30/10/2025
Our ref: DOC/2020/0097
Dealt with by: Eloun Smith

Discharge of conditions 4 and 5 relating to SMD/2020/0213
Rockfields Brambles Paddocks Cheadle Road Wetley Rocks Staffordshire

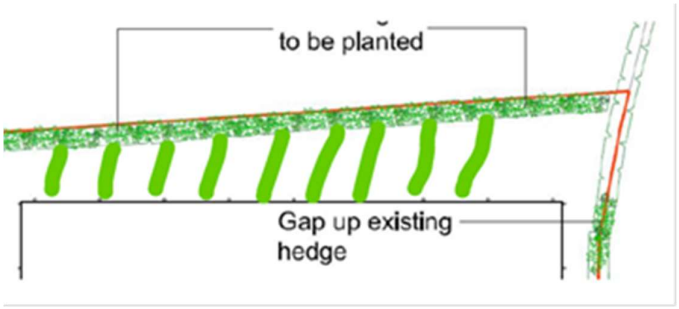
6) Although condition 5 says, the scheme shall in particular provide for retention and reinforcement of existing hedgerows and planting of new native species hedgerows

and shall include full details of all new trees and shrubs, etc and places an emphasis on hedge, we require some tree planting too in this area where hatched green below. This is an area of about 40m2

We would suggest 15no. small 'feathered' sapling tree standards planted haphazardly through this space at c1.5m to c.2m intervals using 5 silver birch (Betula pendula), 5 rowan (Sorbus aucuparia) and 5 oak (Quercus robur).
